# Access Compliance Report

### (Curb Ramps)

| Intersection ID: 16683                  | Main Street: RENSFORD_AV | Cross Street: SHARON_RD                 | Location: NE           |
| ADA ID: 72D5DD6ECAA1                    | Ramp Type: PerpDiag      | Initial Pass/Fail: Fail                 | Overall Compliance: No |

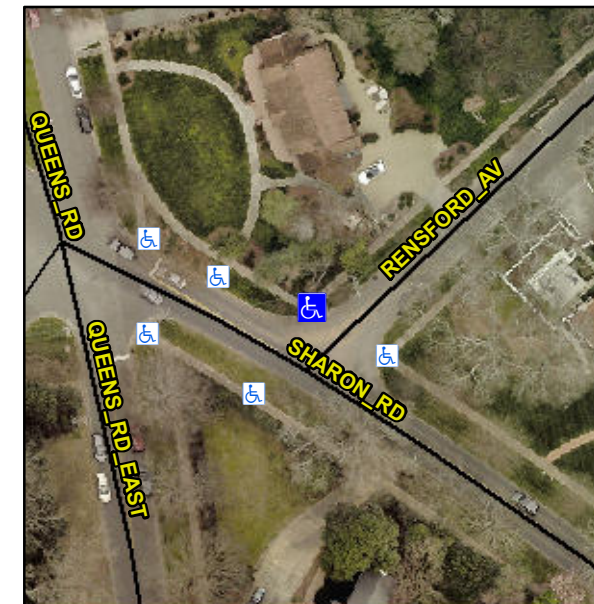
**Not Found, R304.5.1, R304.2.2**

| Compliance | Description           | Data  | Compliance | Description                 | Data  |
|------------|-----------------------|-------|------------|-----------------------------|-------|
| N/A        | Ramp Length (in)      | 64.0  | No         | Ramp Slope (%)              | 9.1   |
| No         | Ramp Width (in)       | 41.0  | Yes        | Ramp XSlope (%)             | 0.3   |

**Remove & Replace Curb Ramp With Two New Directional Ramps or Equivalent.**
